City of Great Falls Public Works/Engineering

INTER-OFFICE MEMORANDUM

City of Great Falls Standards for Design and Construction, OF 1723.0

Proposed Modifications Creating Revision No 1

SAMPLE PORT

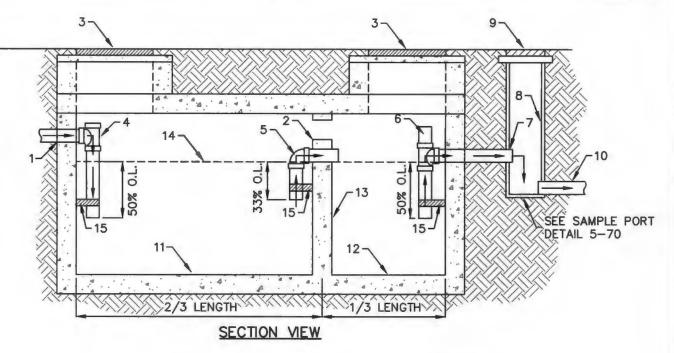
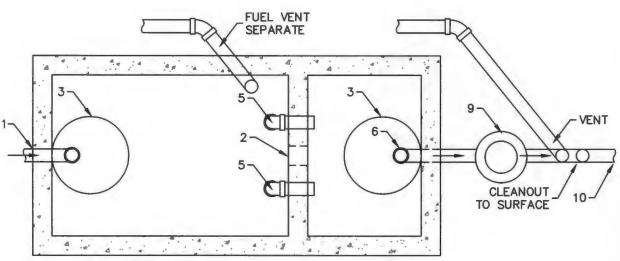
Detail 5-70 Sample Port

TYPICAL EXTERIOR SAND & OIL INTERCEPTOR

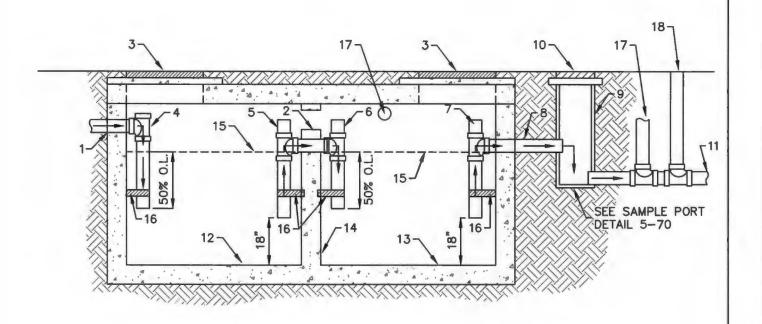
Detail 5-71 Typical Exterior Sand & Oil Interceptor

TYPICAL EXTERIOR GREASE INTERCEPTOR

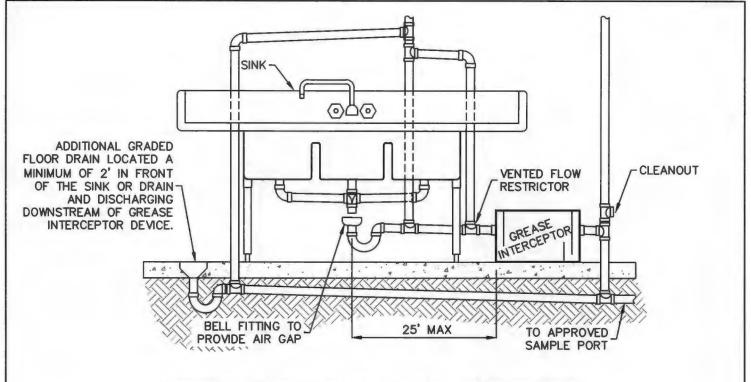
Detail 5-75 Typical Exterior Grease Interceptor

TYPICAL INTERIOR GREASE INTERCEPTORS

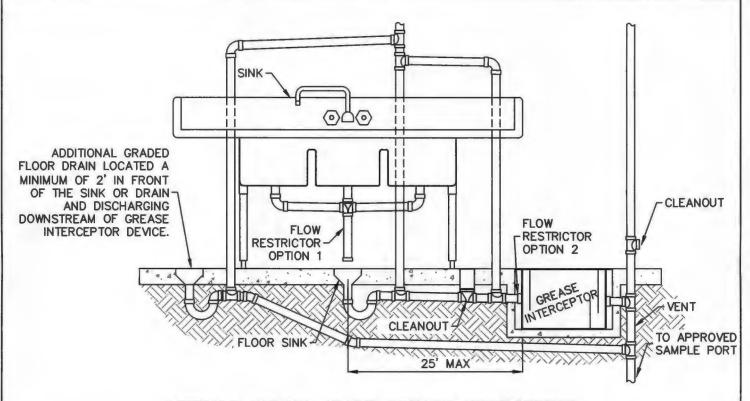
Detail 5-76 Typical Interior Grease Interceptors
